AGENDA
Regular Hybrid Meeting
Town of Granby
Planning & Zoning Commission
Tuesday, June 24, 2025, at 7:00 pm
Town Hall Meeting Room

RE: Application seeking a Site Plan and Special Permit under Zoning Regulations Sections 3.5.4.3, 8.6.14 and 8.21.4 for a commercial building in the Aquifer Protection Overlay Zone with an illuminated freestanding directory sign and outdoor storage, for property located at 14 Mill Pond Drive, C2 Zone: File Z-7-25.

Site Plan Review

Plan: "Proposed Commercial Facility, #14 Mill Pond Drive, Granby, Connecticut 06035, May 2, 2025, Biff Schechinger, Landscape Architect, Revised 4 June 2025, marked up copy revised 6/18/2025."

EAVE SIDE 1 ELEVATION

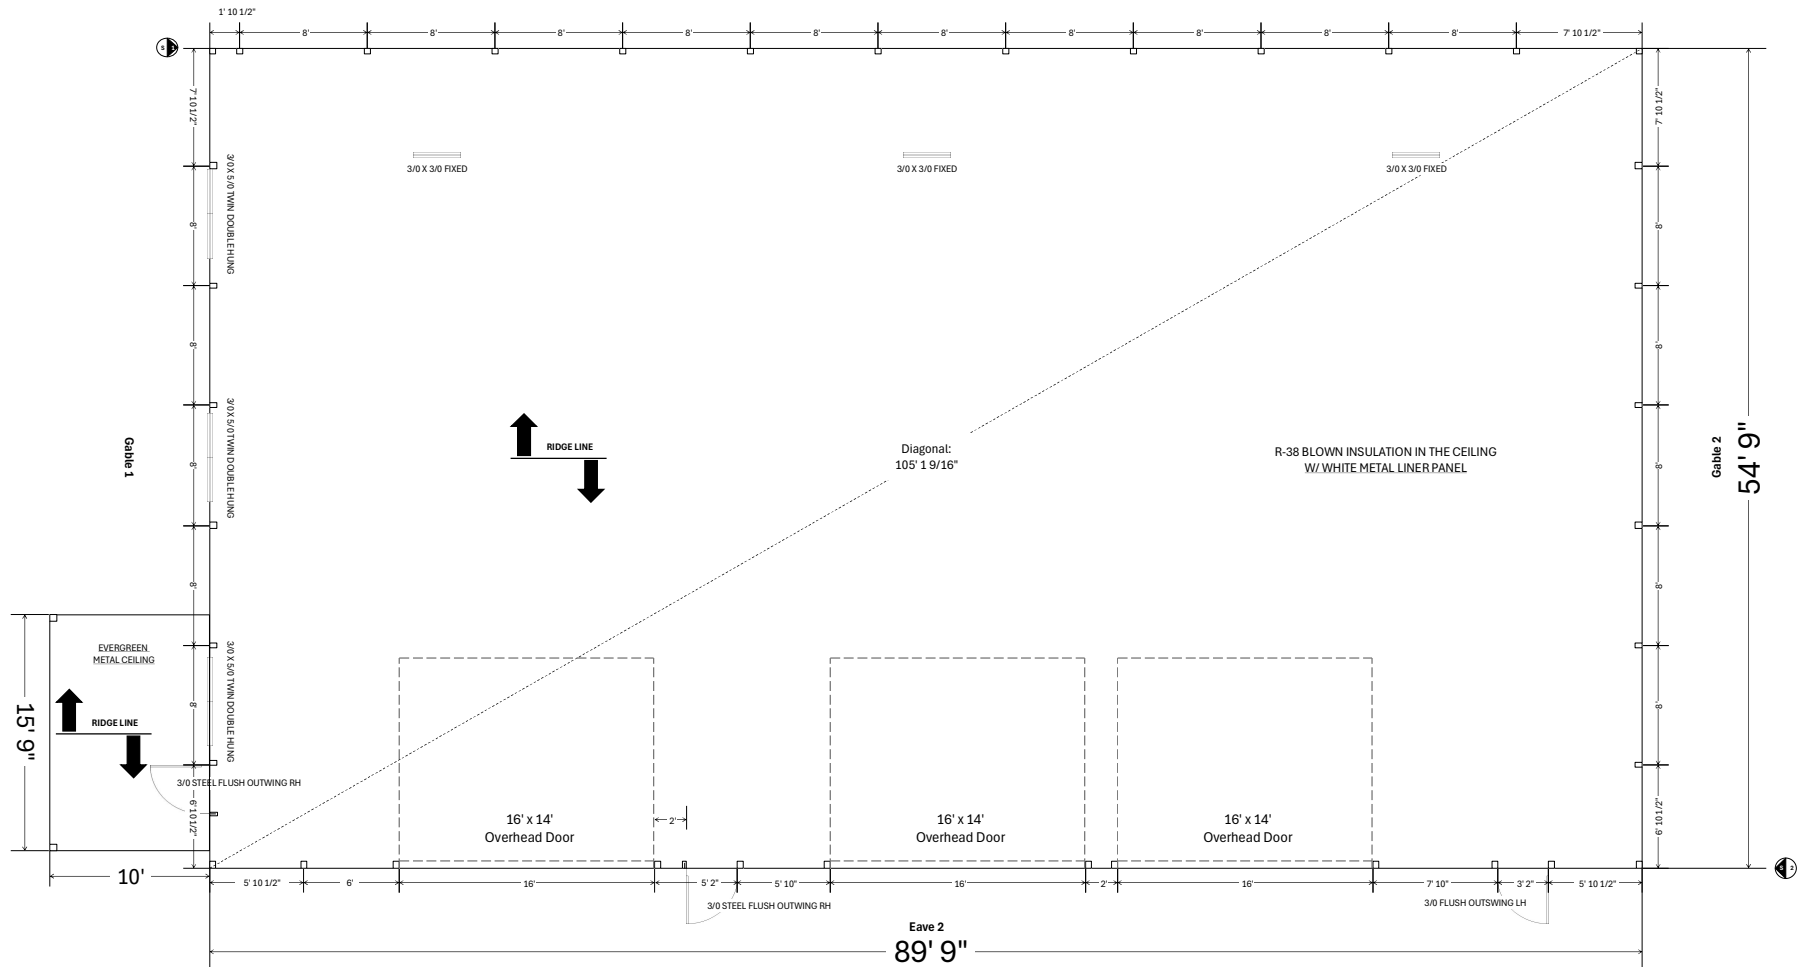
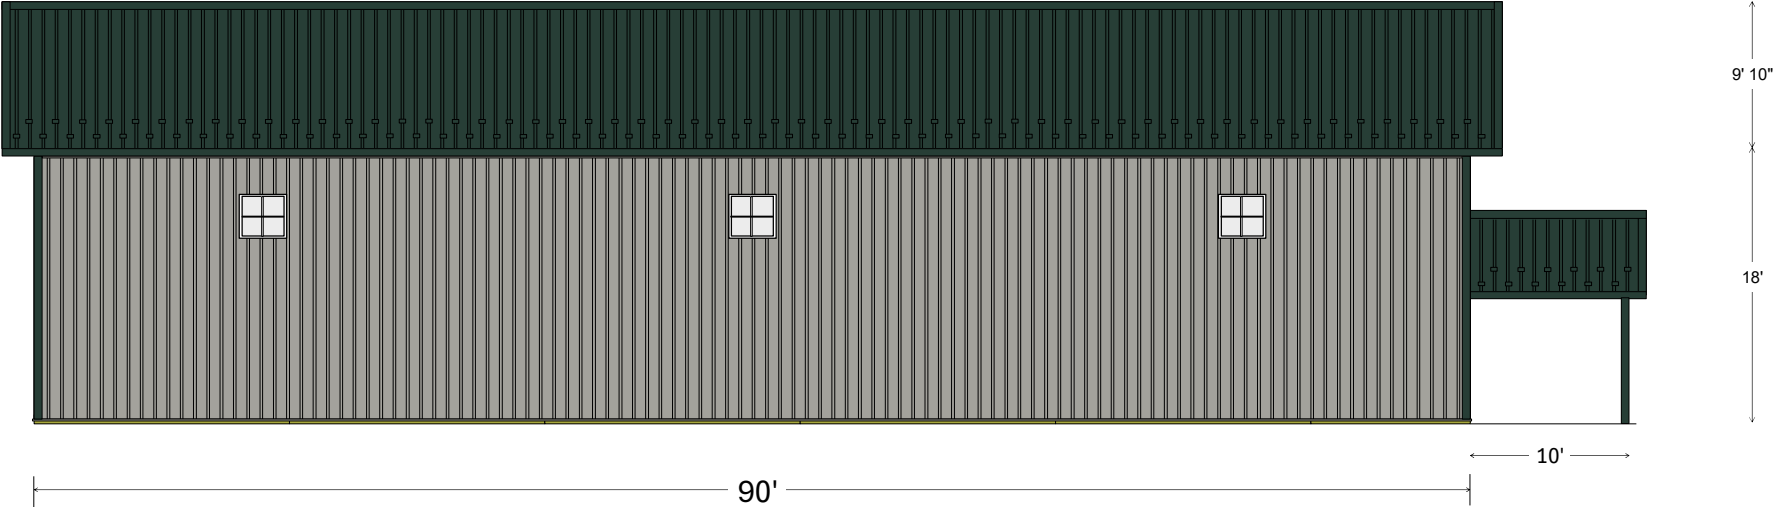
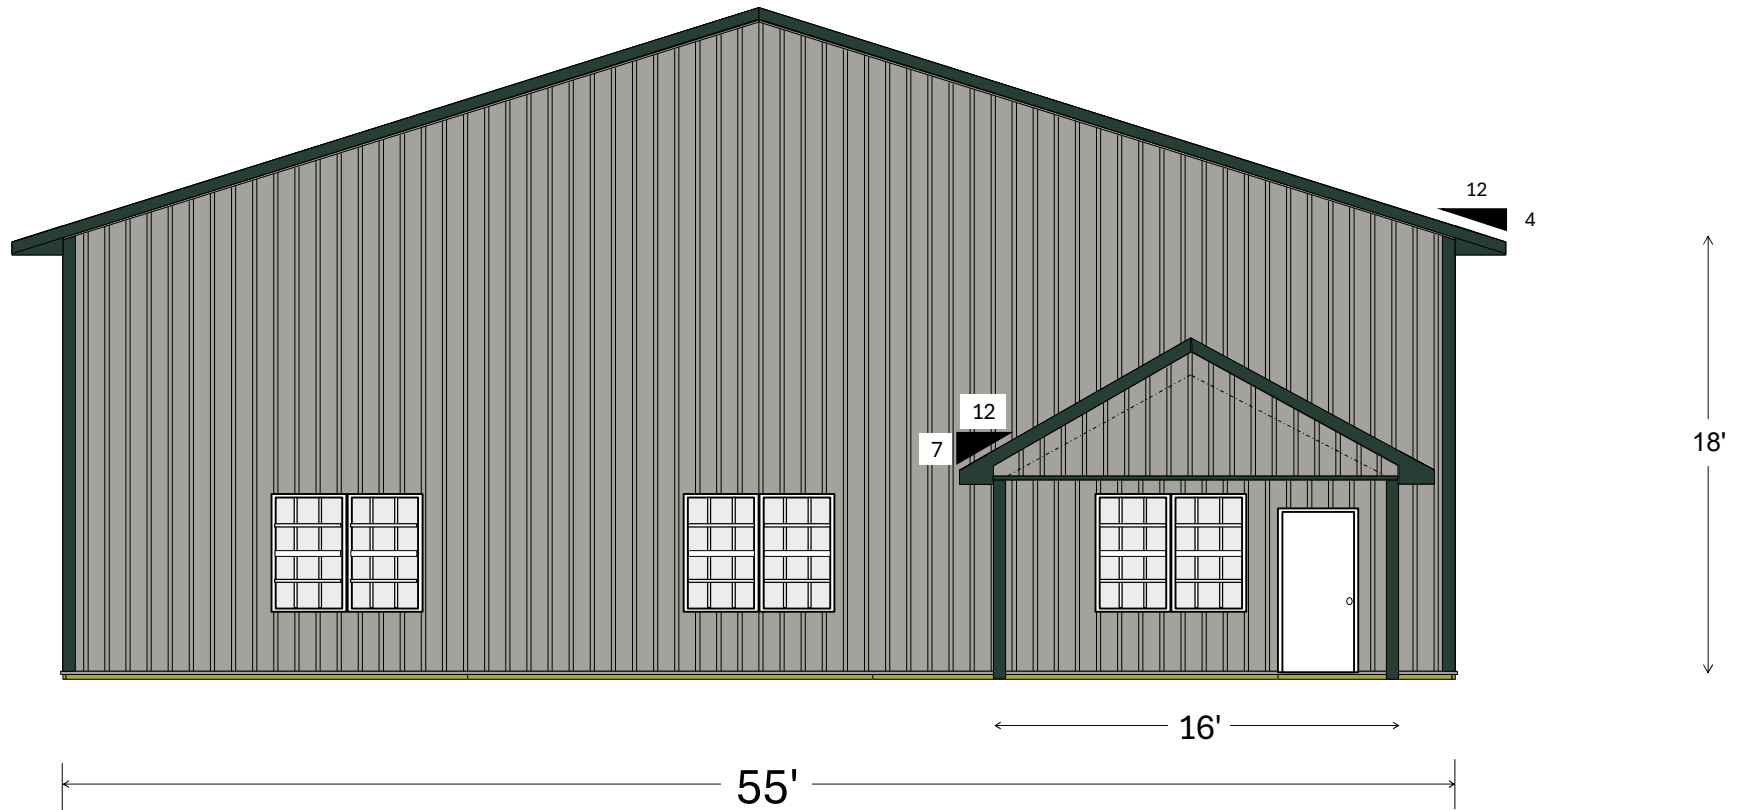
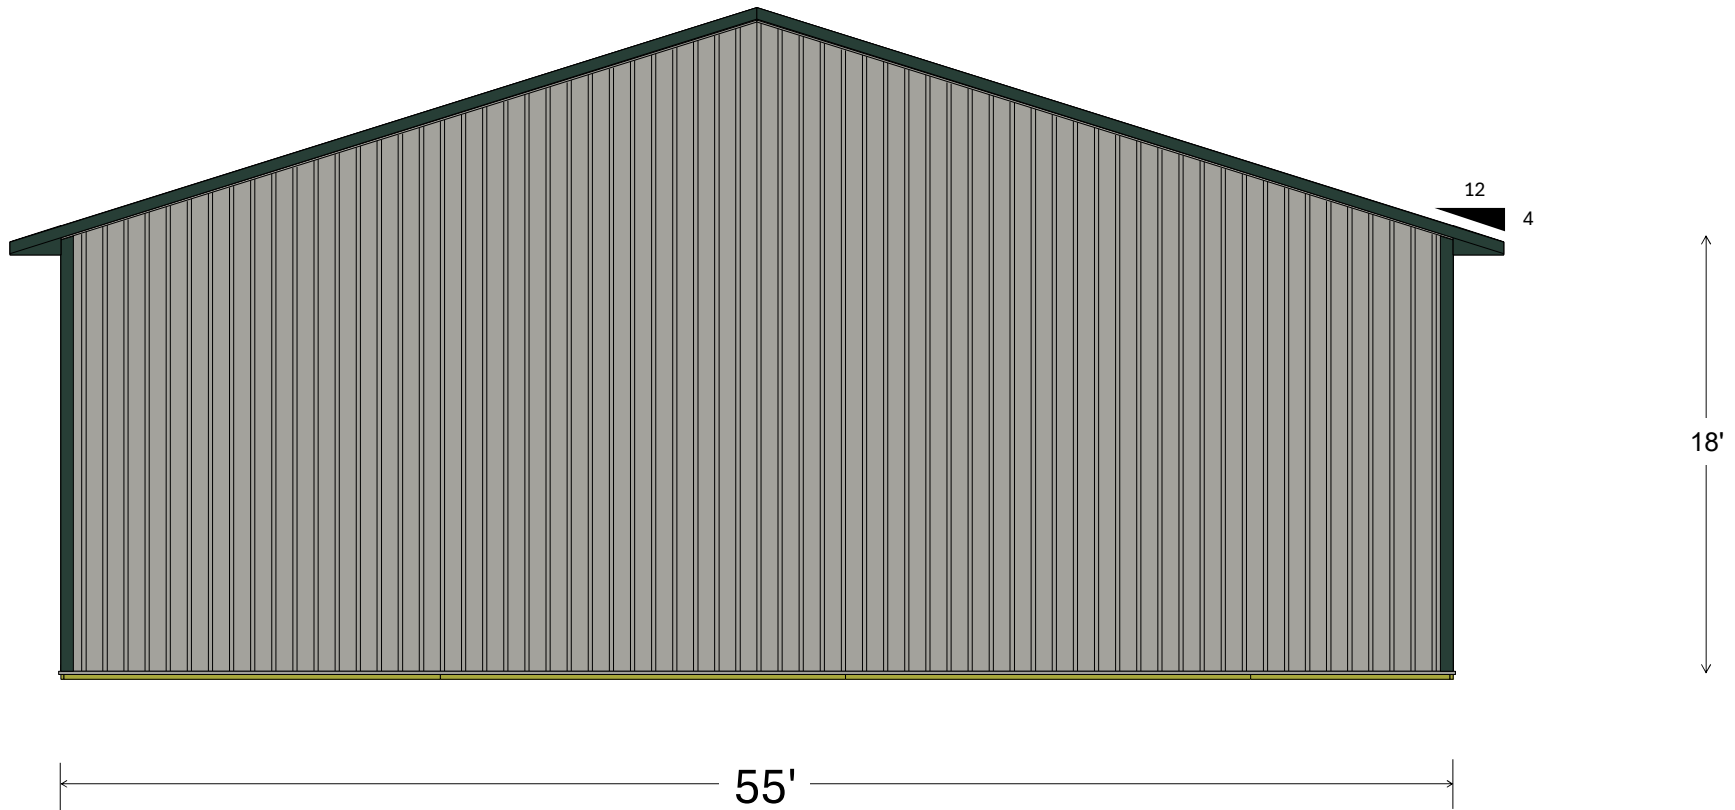
- 1) Provide the updated building elevation showing the pedestrian door and location of the sidewalk. It is understood that the pedestrian door will face Mill Pond Drive.
- 2) Consider adding an awning or roof over the pedestrian door or some other feature on the south building elevation visible from Mill Pond Drive. Another window closer to the peak was mentioned as well. Below are pictures of nearby buildings.
